ONSITE SEWAGE DISPOSAL SYSTEM

PROPERTY ADDRESS: 4807 River Crossing Court

SUBDIVISION: Homewood Crossing

From: Geisert, Andrew
Sent: Monday, May 05, 2014 3:58 PM
To: 'mboyce@eseeng.com'
Subject: Homewood Crossing Lot 71 BAT Plan review

Plot Plan for BAT Installation

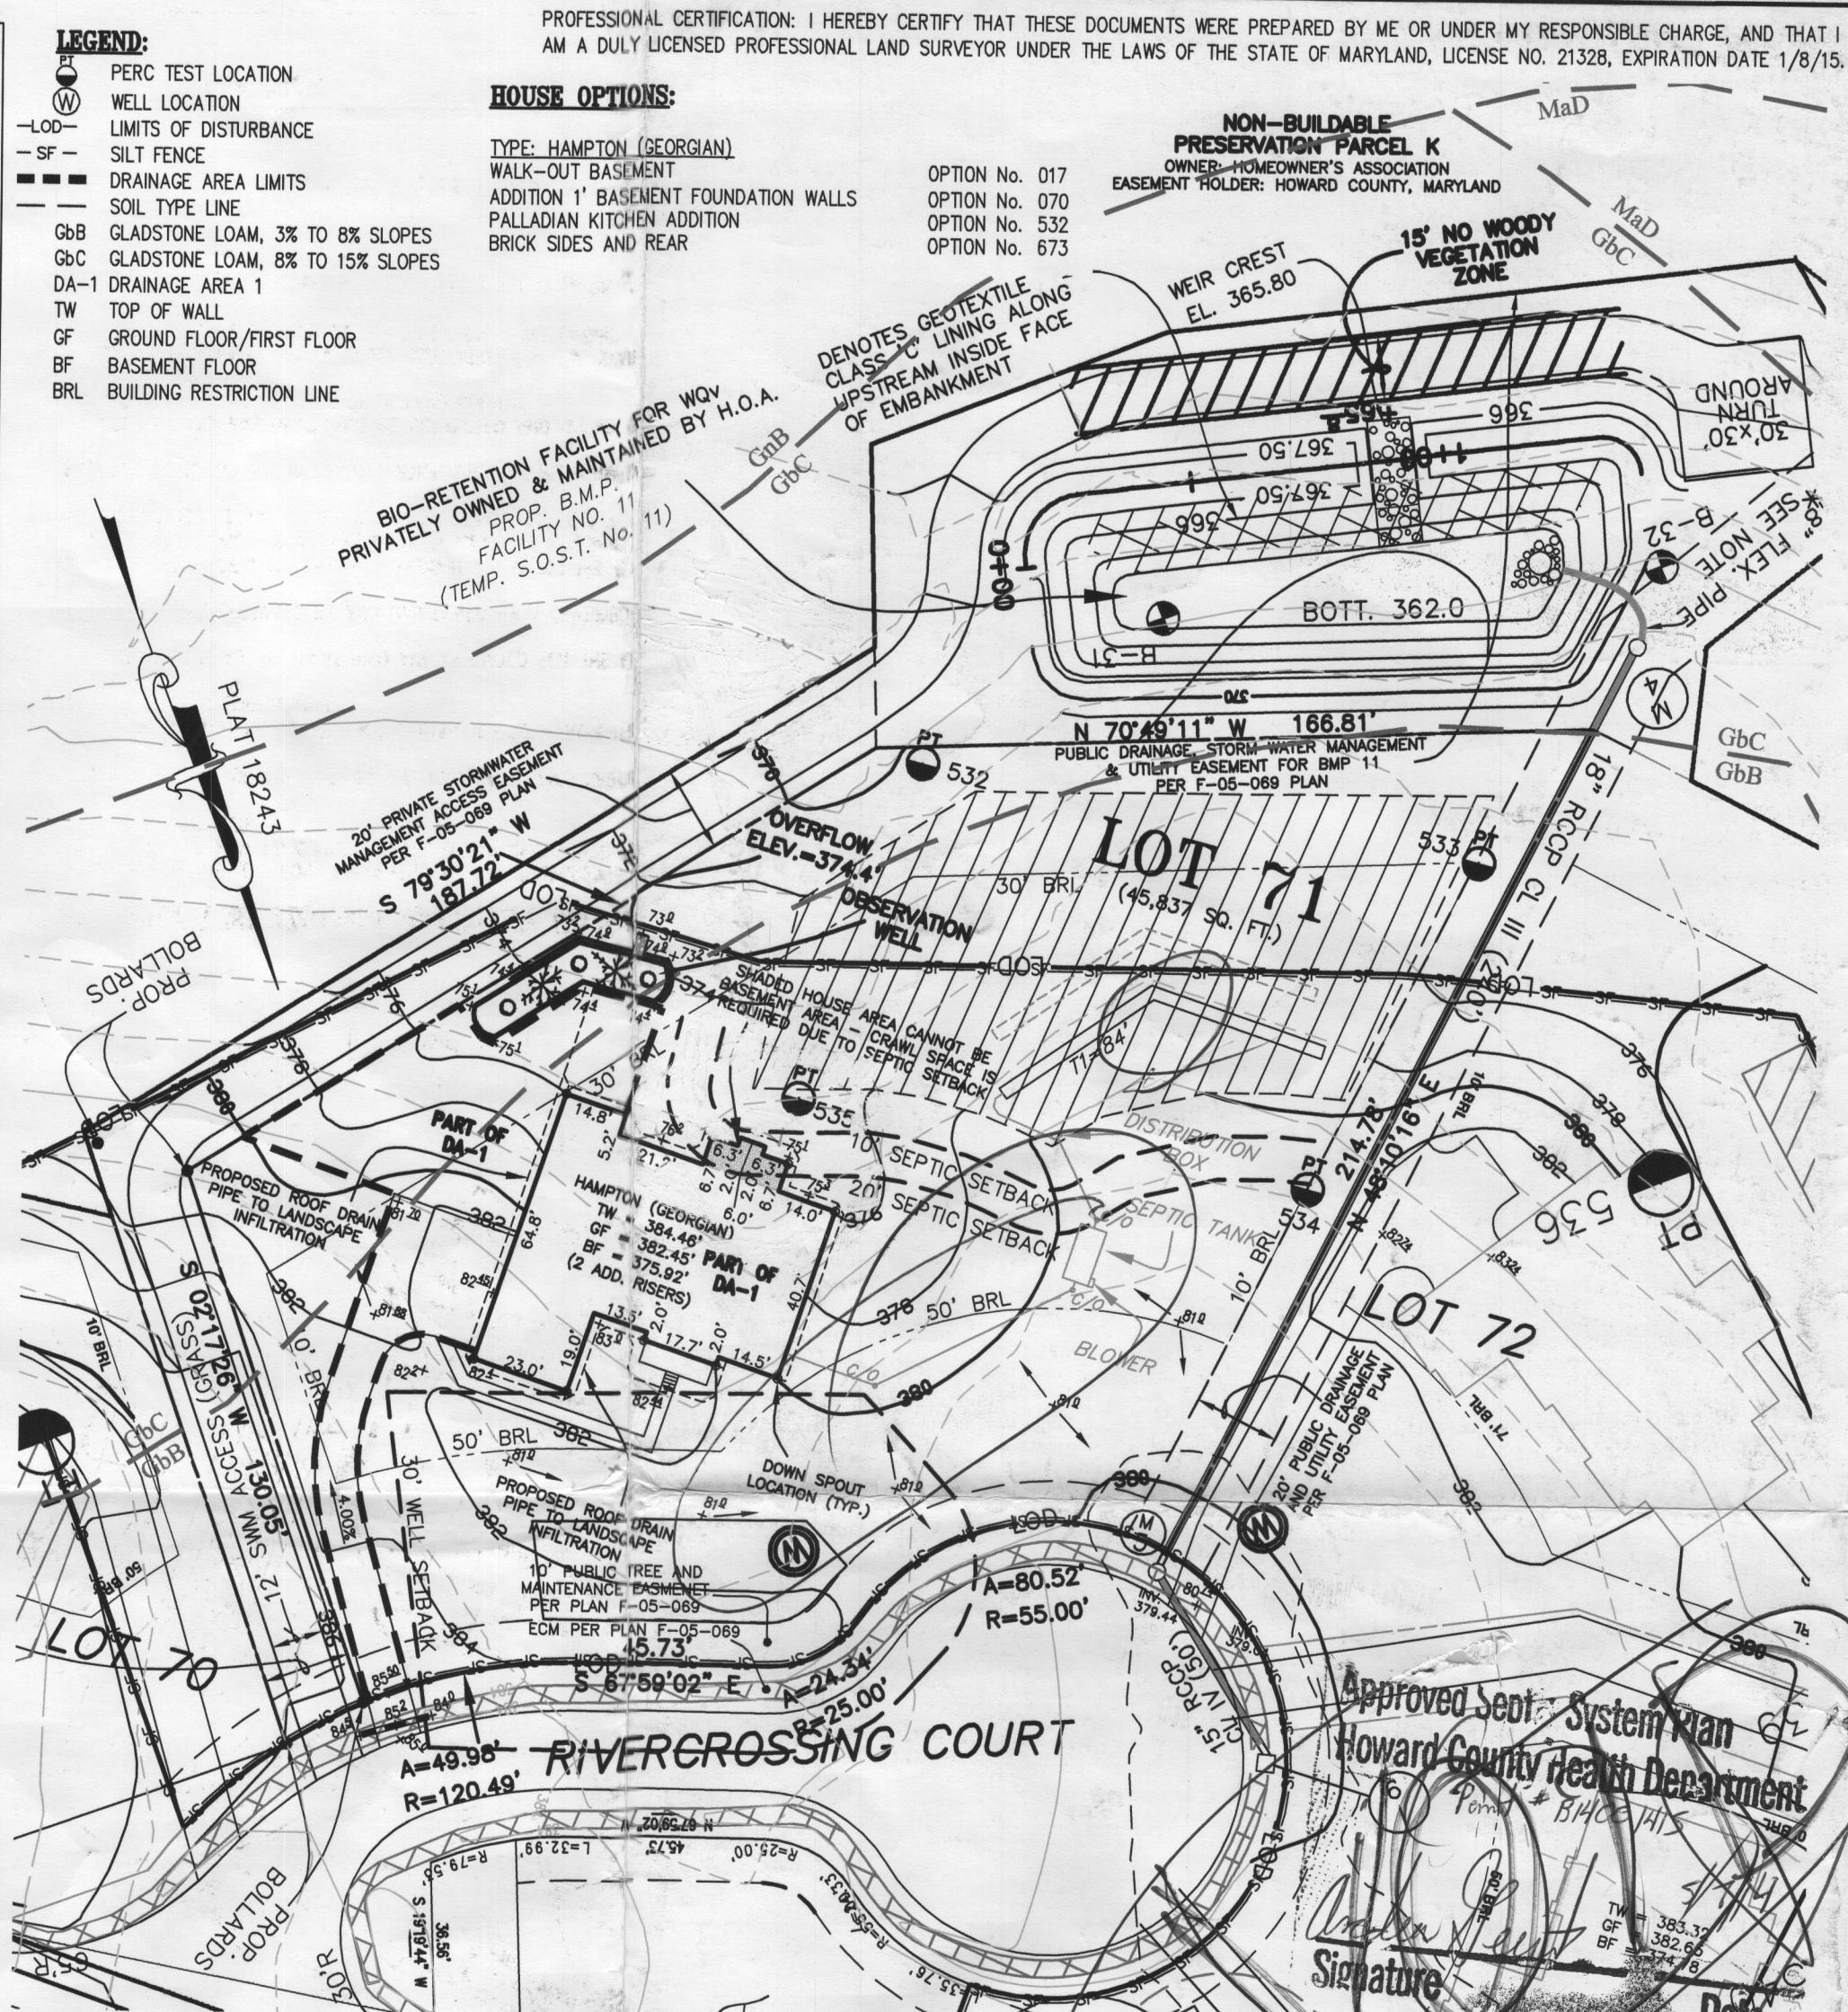
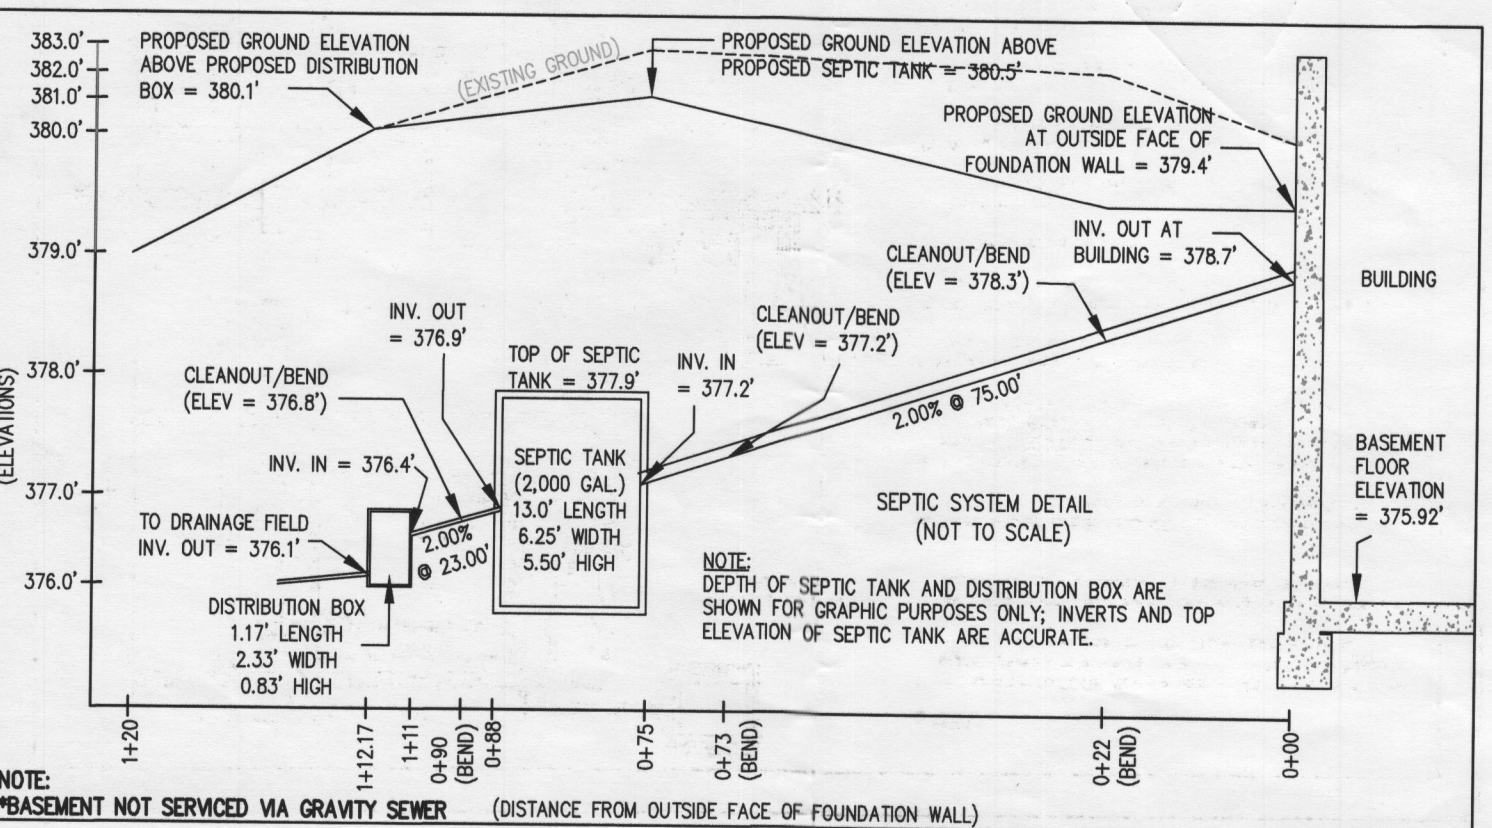
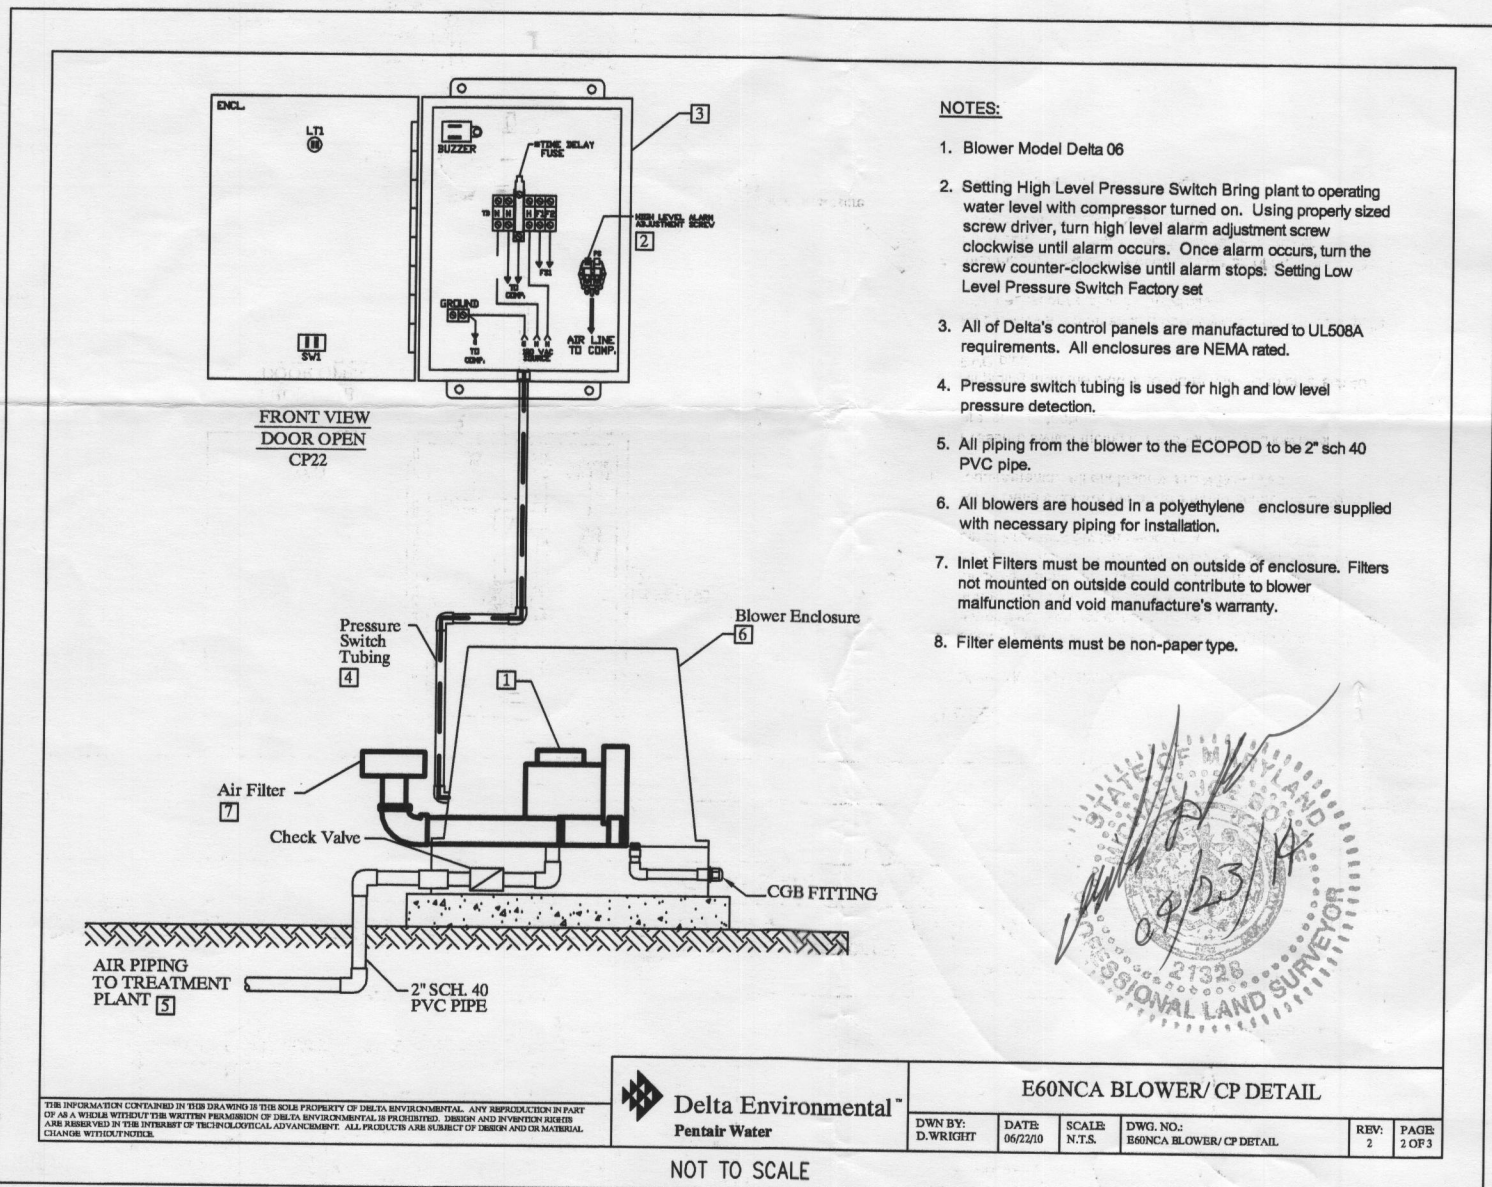
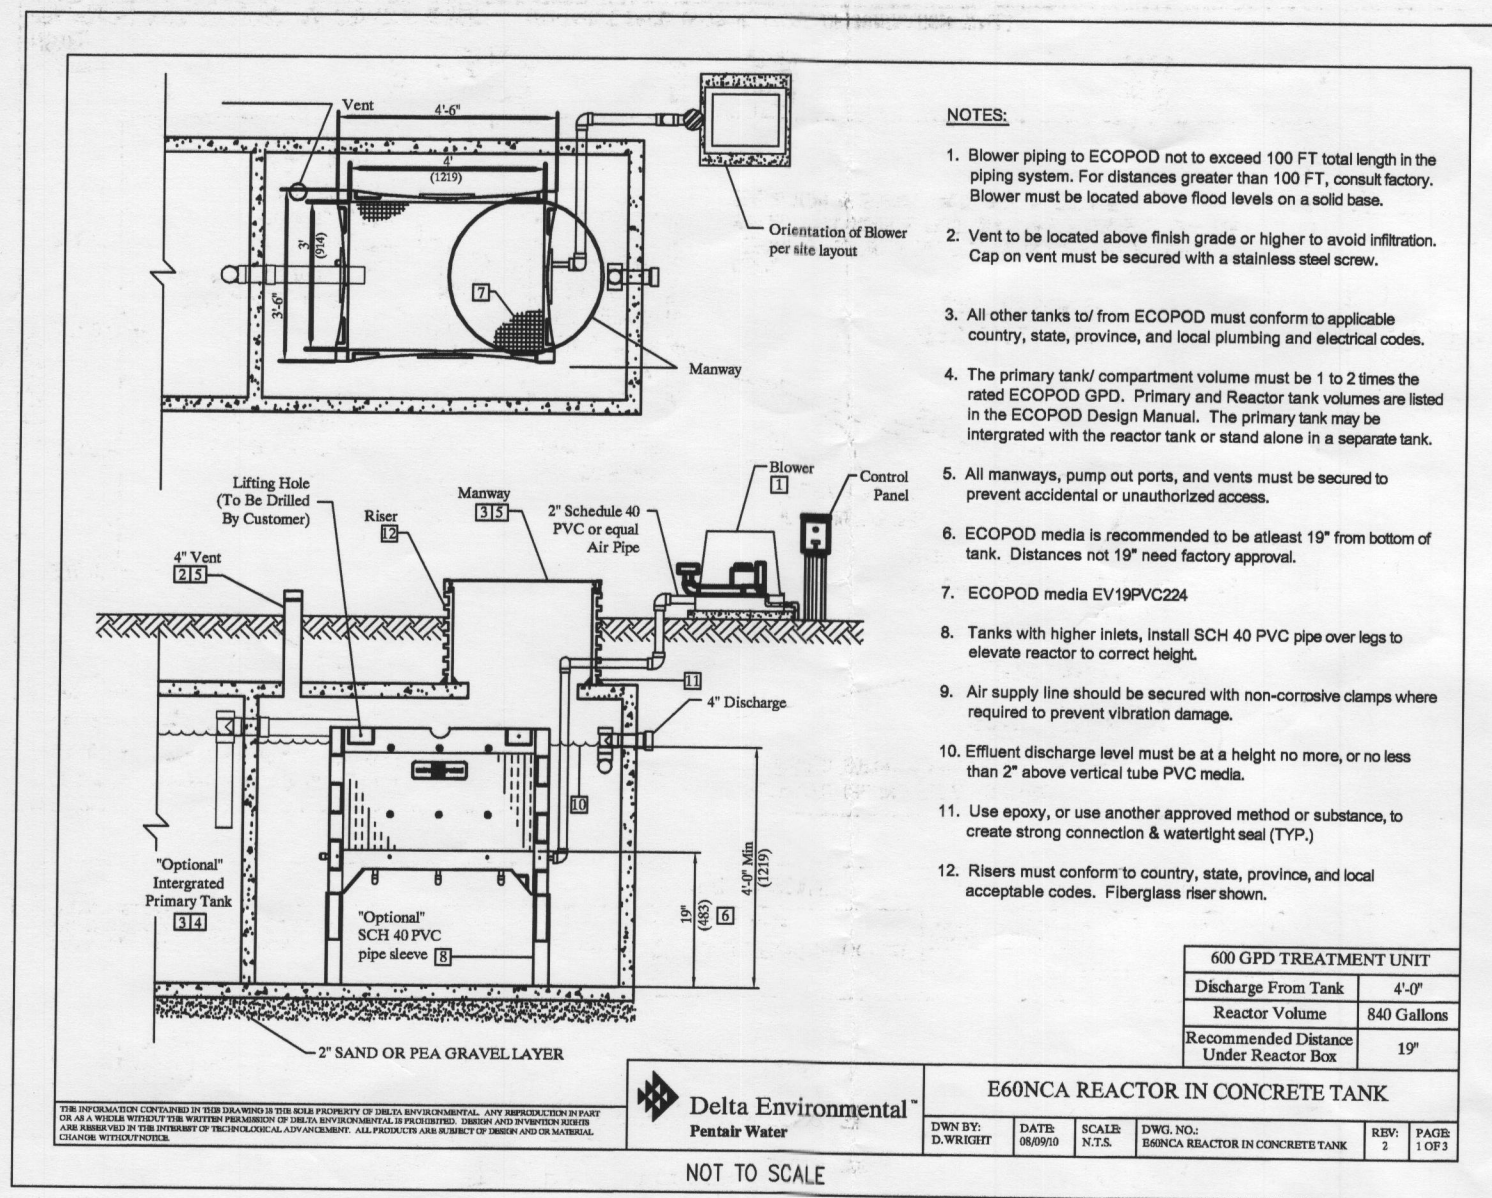
- Only a TRUE deck can be within 20 feet of a sewage disposal area. Even a portion of the house on a crawl space must maintain a 20 foot setback from the easement. Please adjust the location of the house to maintain a 20 septic setback and still maintaining a 30 foot well setback.

My understanding of the 20' setback is to keep the easement away from the basement. We have done this in the past where we allowed a crawl space to be within the 20' setback.

As you can see, there is not any room to adjust the house and stay out of the well setback.

All of the trenches, primary, second and third (not shown) will be more than 20' from the house and 2' below basement floor or better.

- Only a TRUE deck can be within 20 feet of a sewage disposal area. Even a portion of the house on a crawl space must maintain a 20 foot setback from the easement. Please adjust the location of the house to maintain a 20 septic setback and still maintaining a 30 foot well setback.

I spoke with Mike following your e-mail response. A 10 foot setback will work for the crawlspace.
